**IS : 6639 - 1972 SPECIFICATION FOR
HEXAGON BOLTS FOR STEEL STRUCTURES**

AMENDMENT NO. 1 APRIL 1978

AMENDMENT NO. 2 OCTOBER 1981

(Page 1, Table 1):

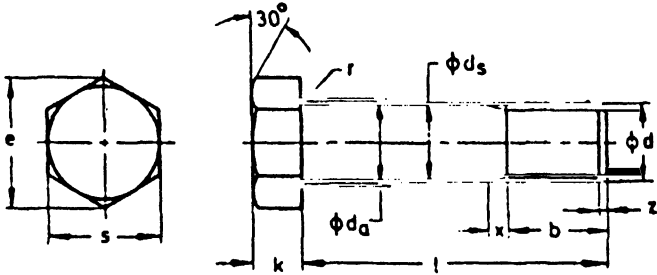
a) Figure — Substitute the following for the existing figure:
